1. No Meeting Agenda

1.1. Old Business

# 78 Wauwinet LLC

78 Wauwinet Road  
Nantucket, MA 02554

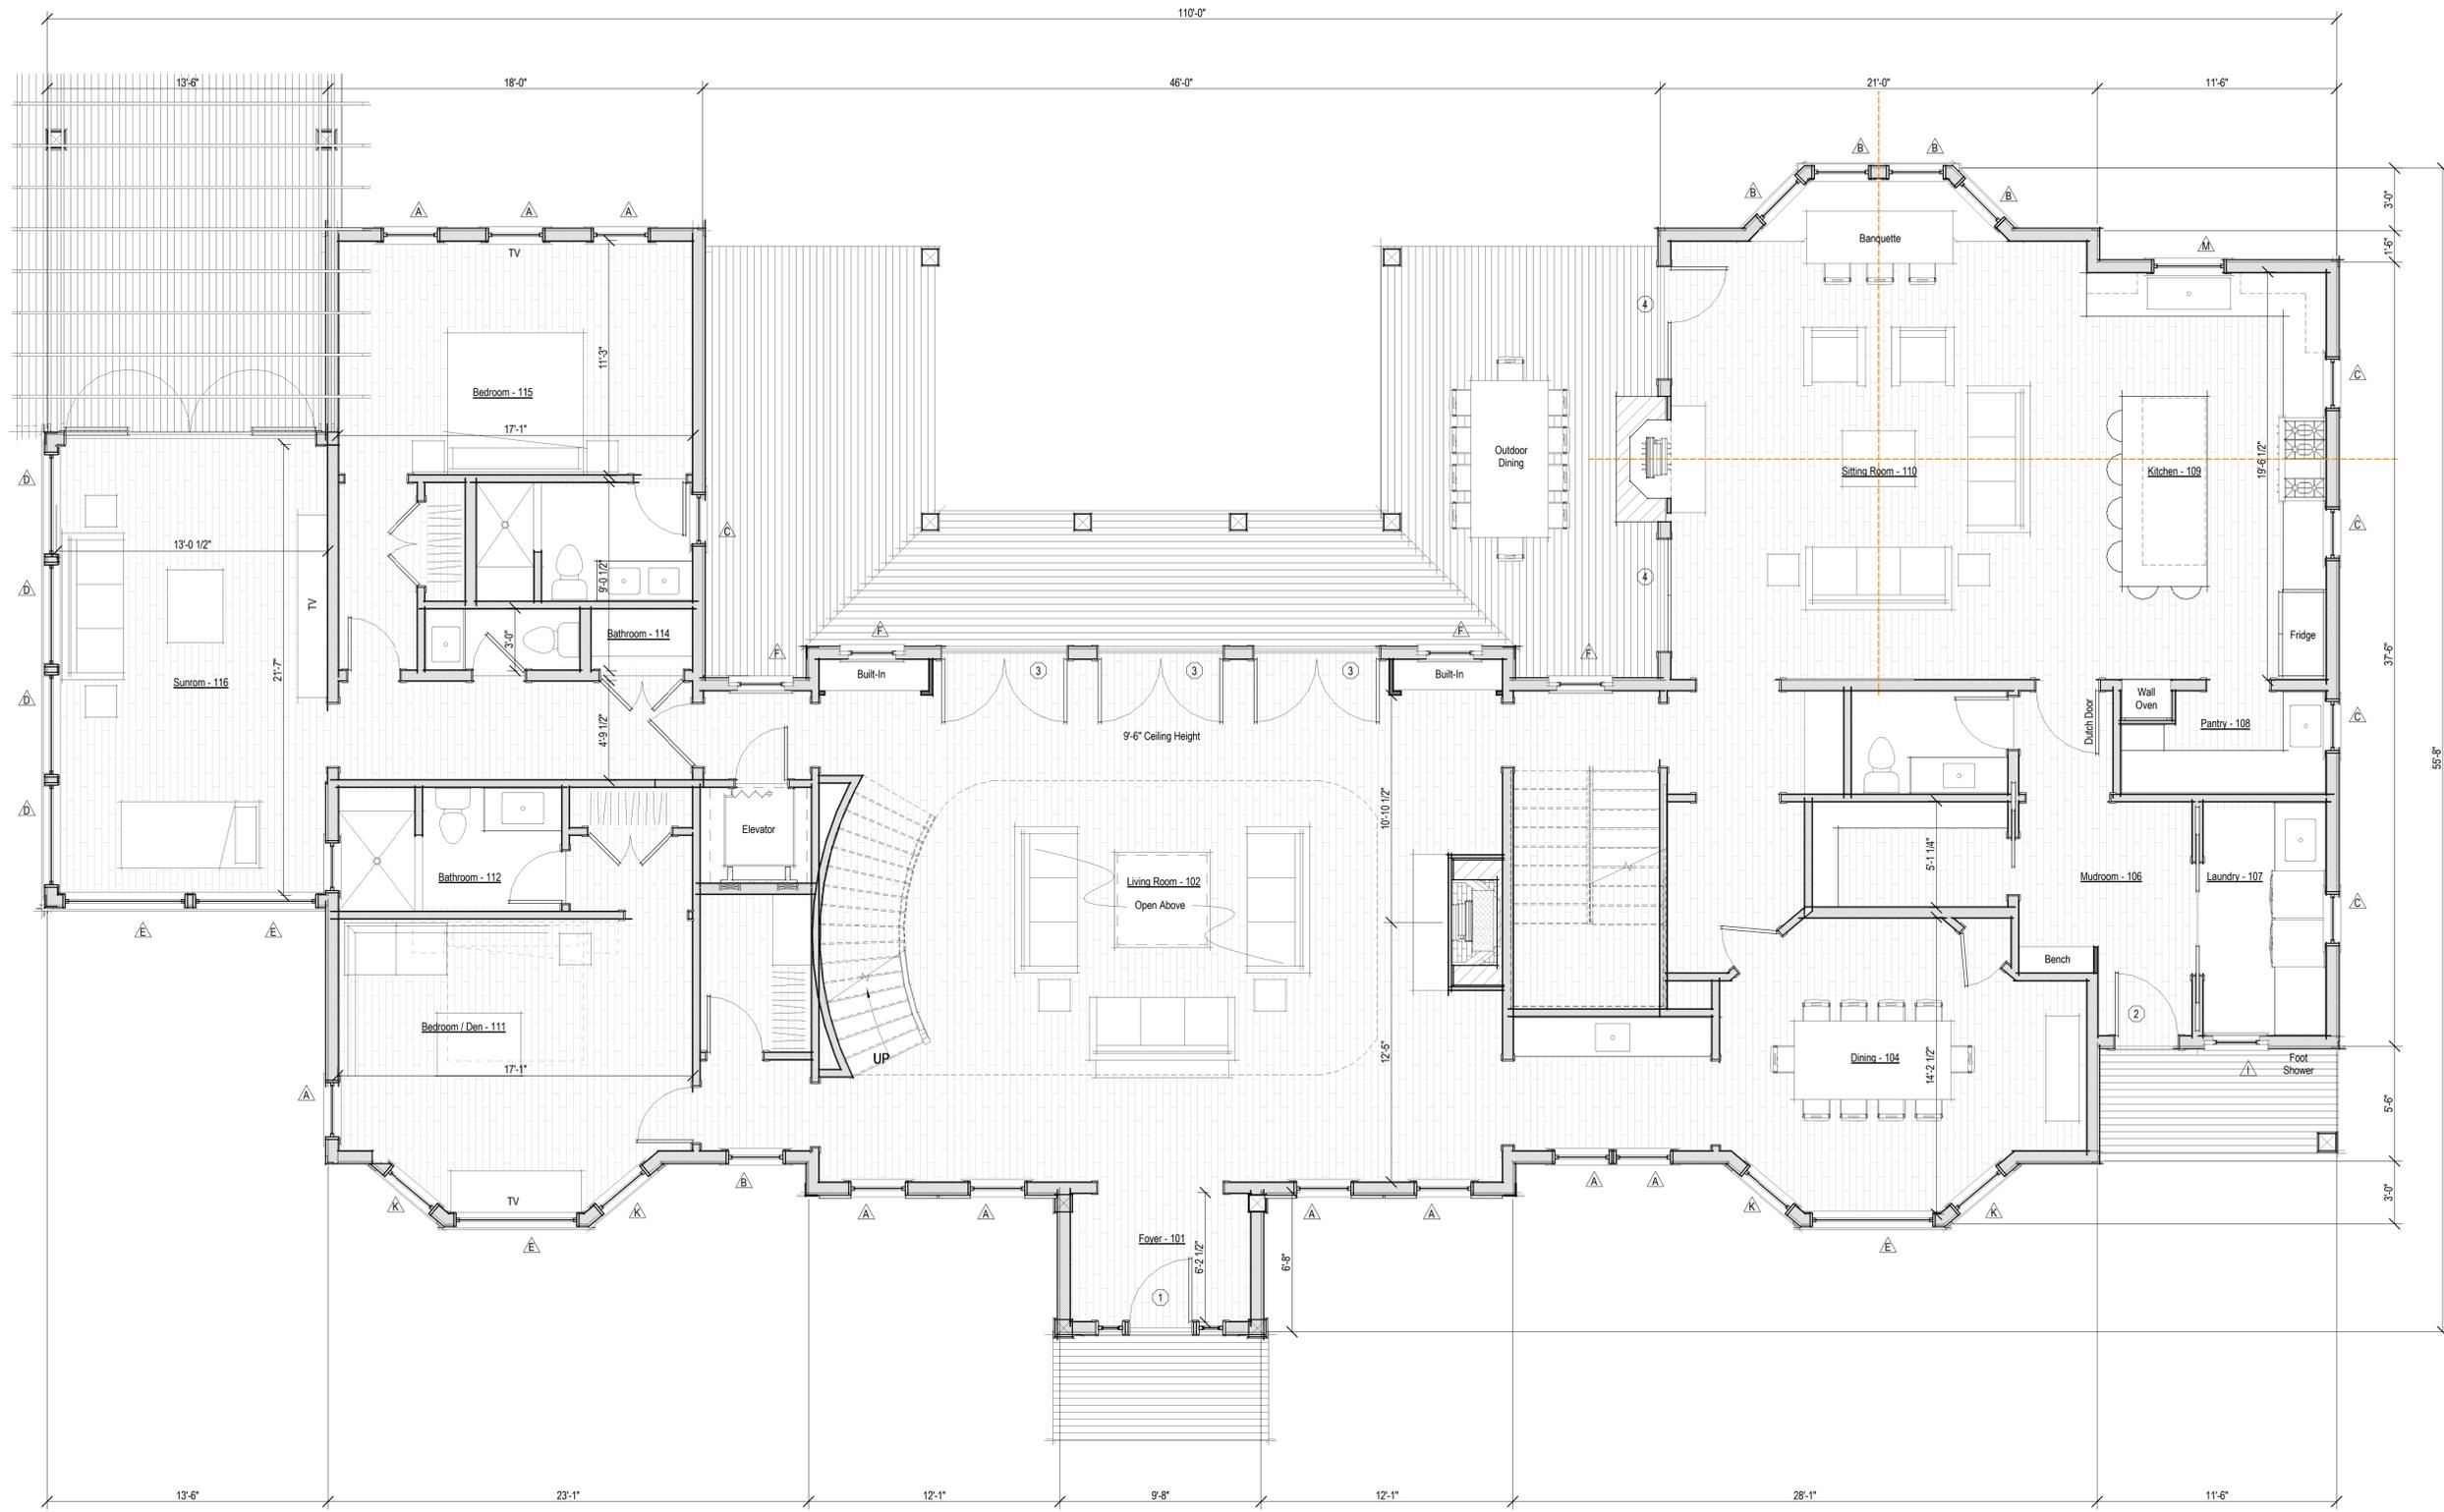
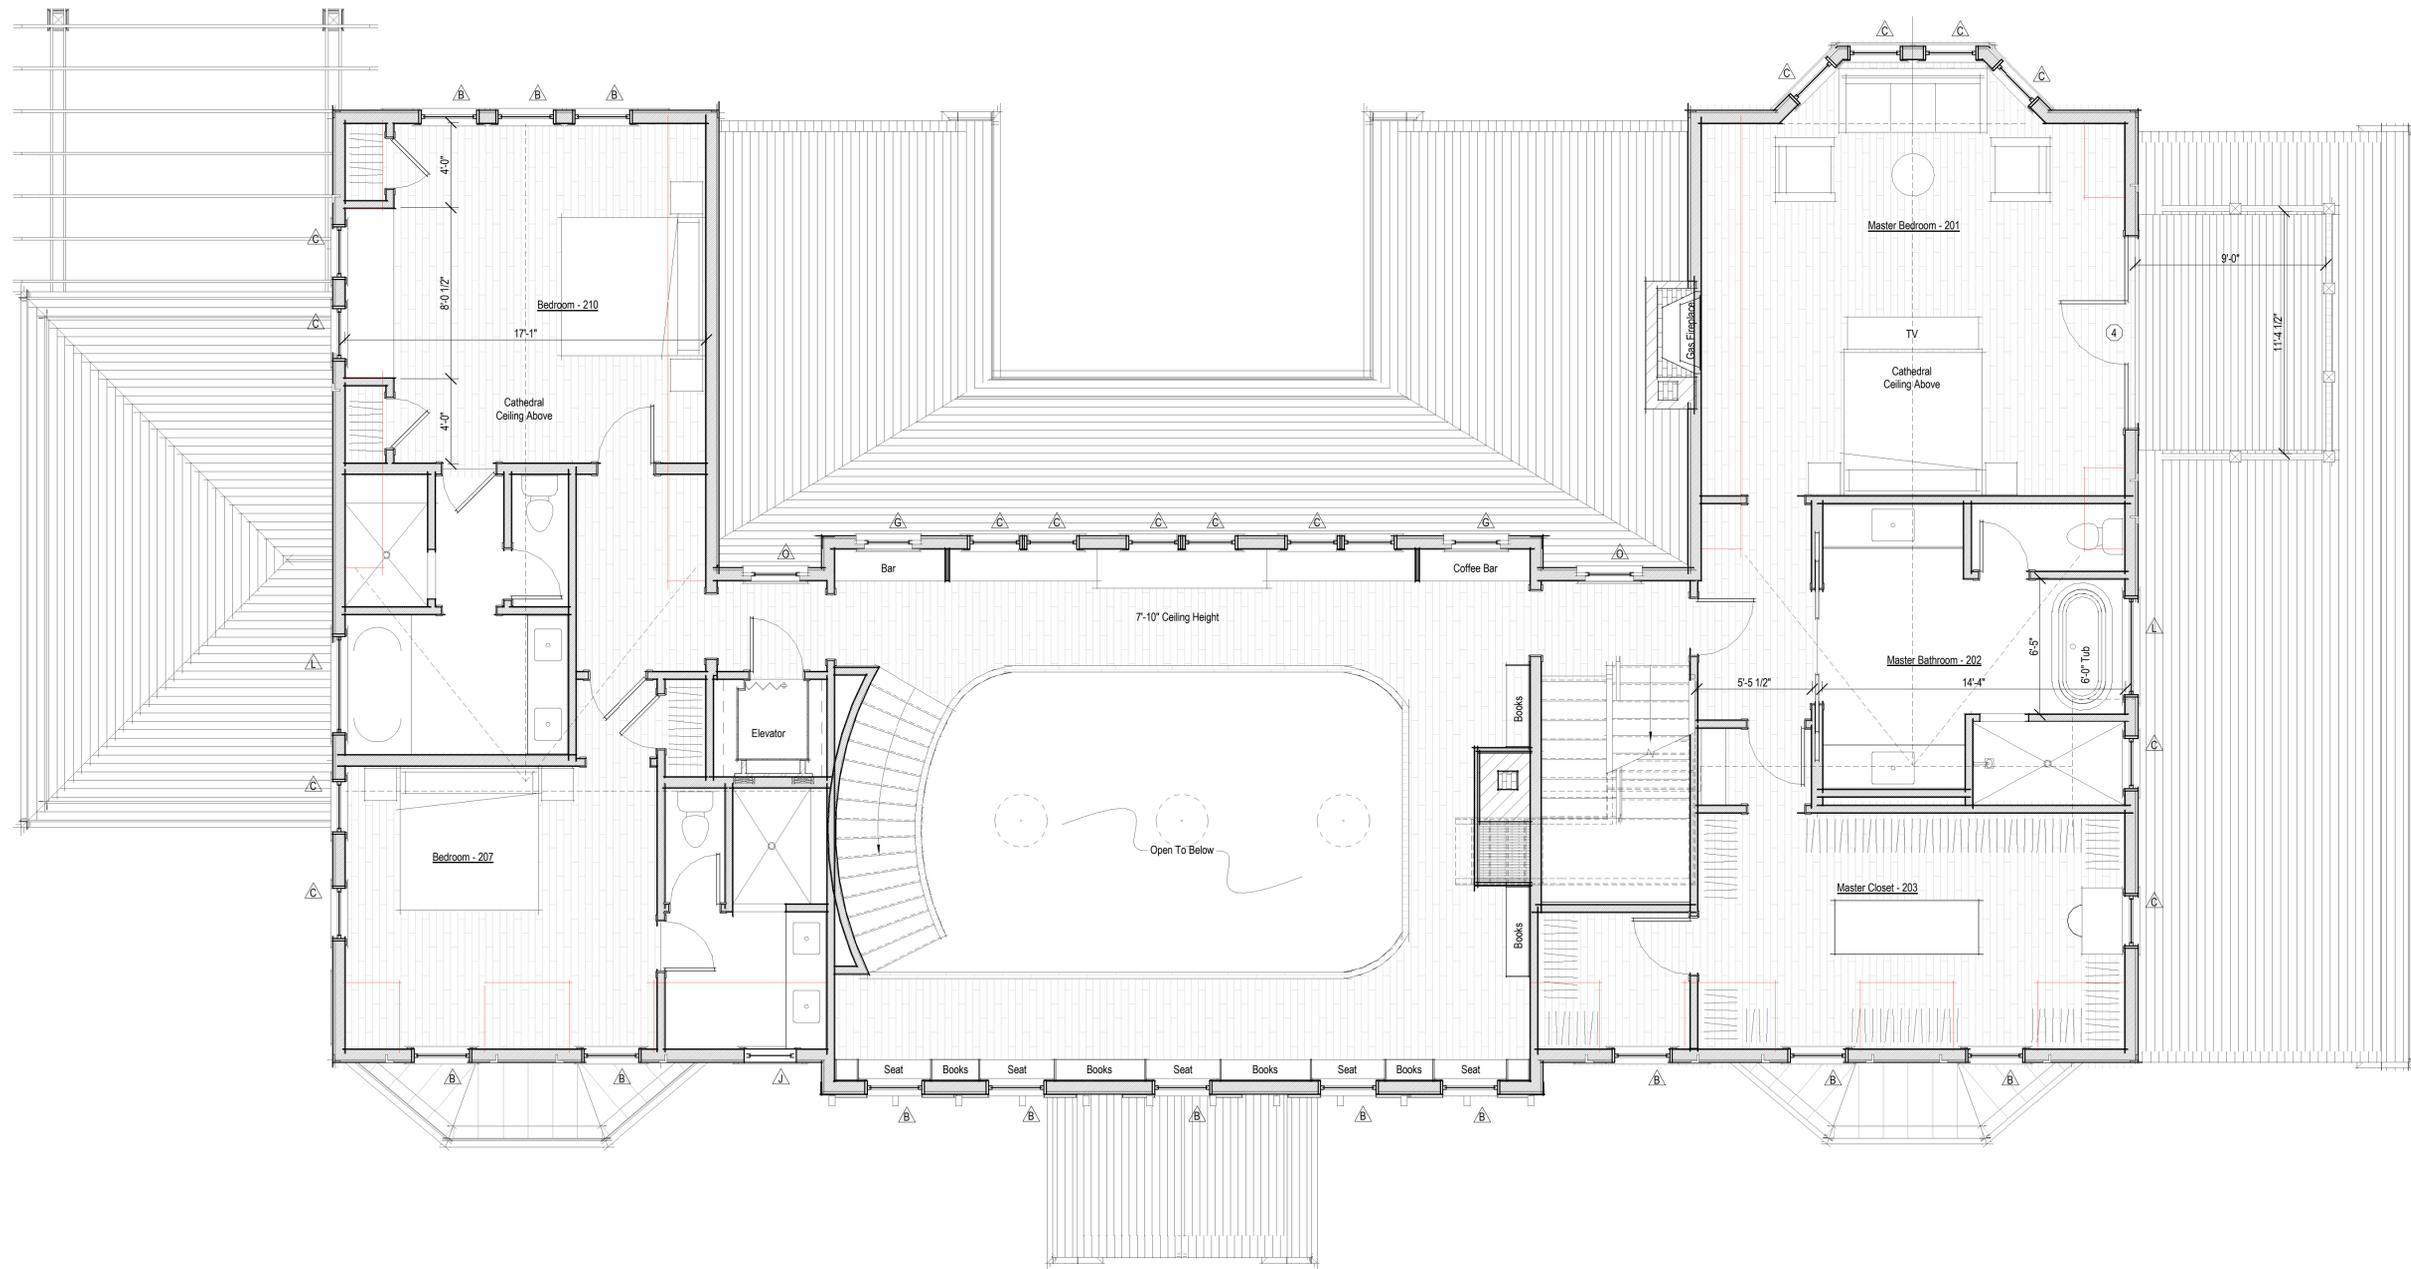
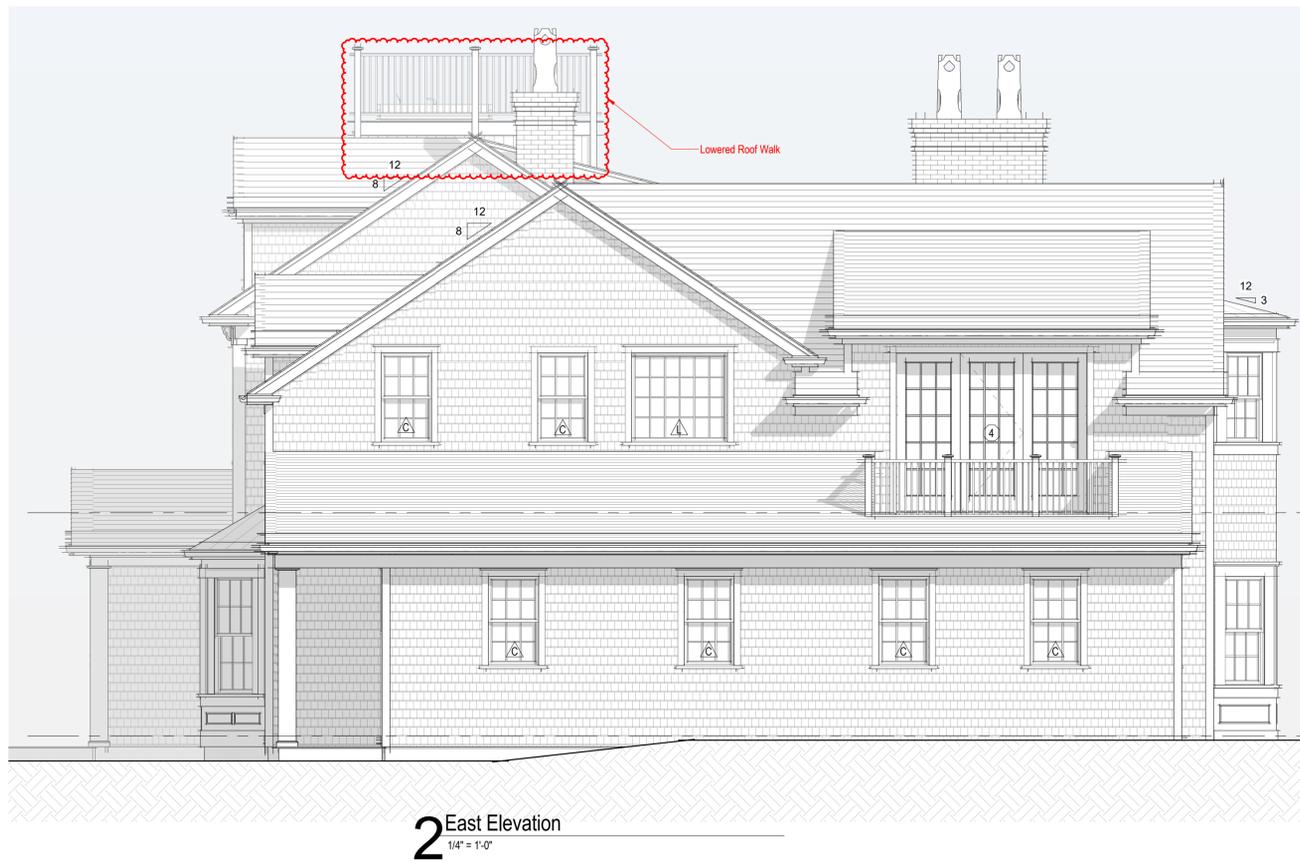
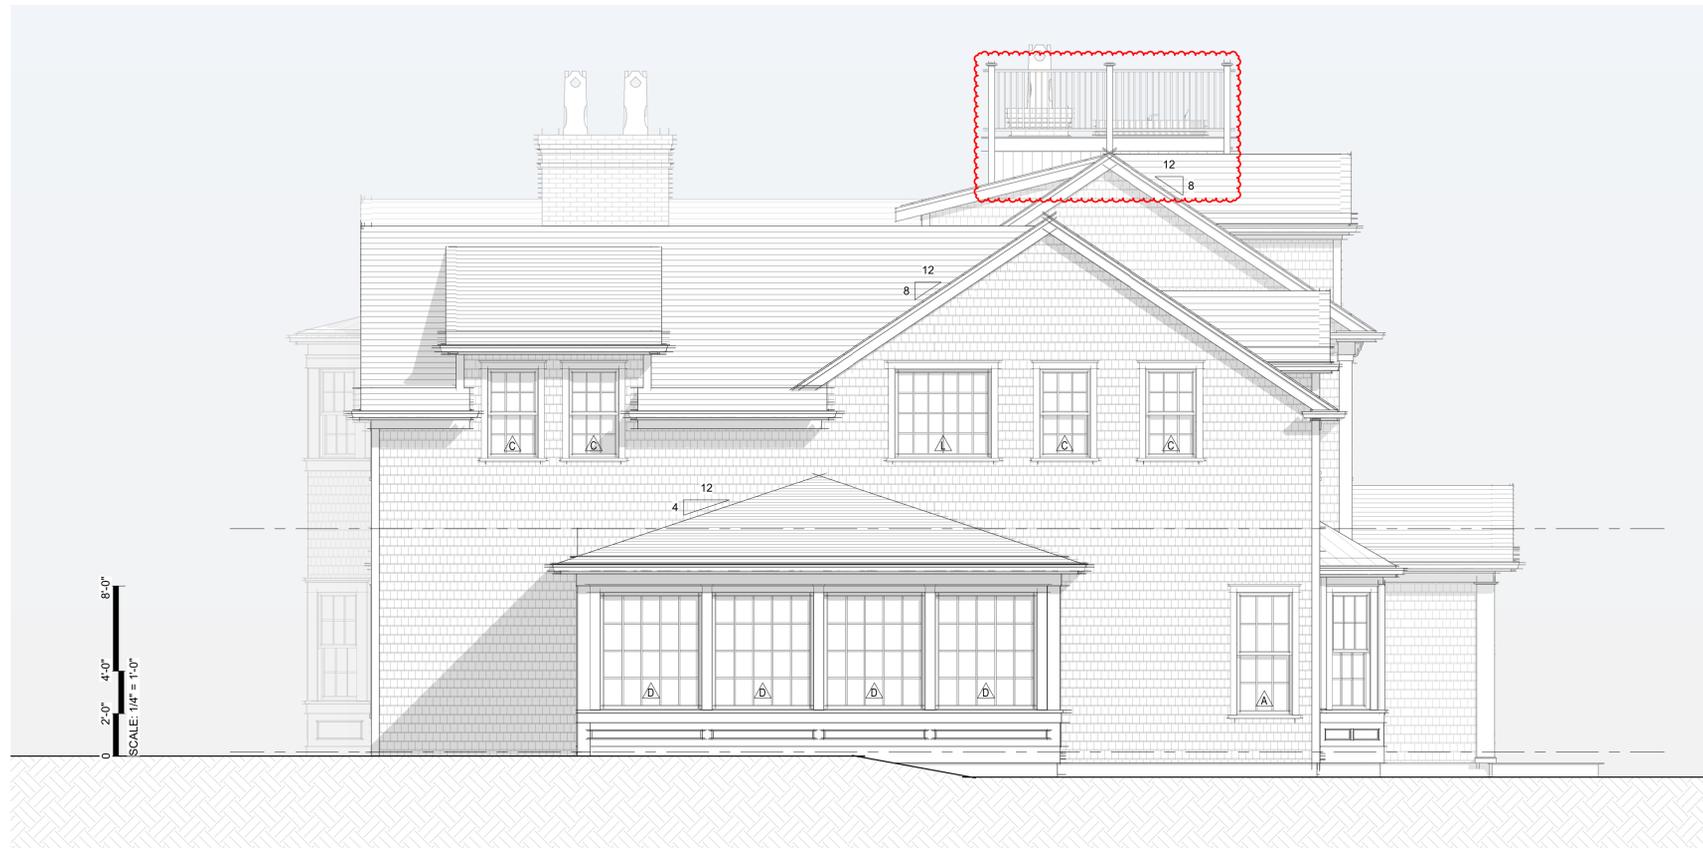
7.	78 Wauwinet LLC 06-1065	78 Wauwinet Road	New dwelling	14-18	Emeritus
Voting	Pohl, Coombs, Camp, Oliver, Welch				
Alternates	None				
Recused	None				
Documentation	Architectural elevation plans, site plan, and photos.				
Representing	Matt MacEachern, Emeritus Development				
Public	None				
Concerns (5:26)	<p><b>MacEachern</b> – We put up ridge poles if the commissioners want to ascertain visibility; reviewed context photos and 3D renderings and changes made per previous concerns.</p> <p><b>Oliver</b> – Asked what part of the house the height pole represent in the photo from Fargo – west 27-foot ridge. The roof and 3<sup>rd</sup>-floor dormers will be visible.</p> <p><b>Coombs</b> – If the roof walk were lowered, the skirt would be smaller; currently the skirt takes up half the roof and sits on the dormers. The panel shutters don't fit with this style of house; they should be louvered. The house is 110 feet long; suggested bringing in the south elevation, right-side wall to reduce the length. If this family owned the property for 40 years, she doesn't understand why they need a viewing platform on the property.</p> <p><b>Camp</b> – She shares the concern about the height. The main mass is overwhelmed by the right side but we're being told it won't be visible; we've been burnt a couple of times by brush cutting; if this is cleared to Fargo Way; it will stick out.</p> <p><b>Welch</b> – Asked about the frieze area on the South elevation. He agrees with comments made. To the extent this is visible, the Fargo view indicates the left section is 61 feet plus from the road; the main mass ridge would be only about 20 feet from the shown height pole. He wants to see a topographical site plan showing the neighbor's tennis court; it looks like the driveway will be at elevation 22 feet with the house stepped up a foot putting the top of floor around 23'6". The elevation at the house then drops to 10 feet at the ocean; feels that side of the house will be seen, especially without jurisdiction over clear cutting. We should be viewing retainage in connection with the house application.</p> <p><b>Pohl</b> – Other houses in the neighborhood are 2-stories with no 3<sup>rd</sup>-floor dormers; he feels everything above the 2<sup>nd</sup>-floor eave will be visible and it is all white. The skirt board on the roof walk traditionally would sit on the ridge; here it is 1-foot above the ridge, apparently for head room underneath. The skirt board should be 1-foot lower, which would lower the roof walk 1 foot. If this owner wants to clear cut to Fargo Way, we have no recourse to stop them; in his opinion, that makes the massing "fair game." The elevations show a flat site when there appears to be a 6-foot grade change over the footprint; he'd like to see an existing topo with the proposed topo to see ascertain how a flat site would be achieved. It's the ConCom who have enforcement power if cutting encroaches into the resource area no-disturb buffers.</p>

Motion	<p><b>Motion to Hold for revisions and additional information to include a topographical map showing existing with overlay of proposed and indications of the neighbors to the northwest and a cross section through the southwest showing retainage. (Welch)</b></p>				
Roll-call Vote	Carried 5-0//Oliver, Camp, Coombs, Welch, and Pohl-aye.			Certificate #
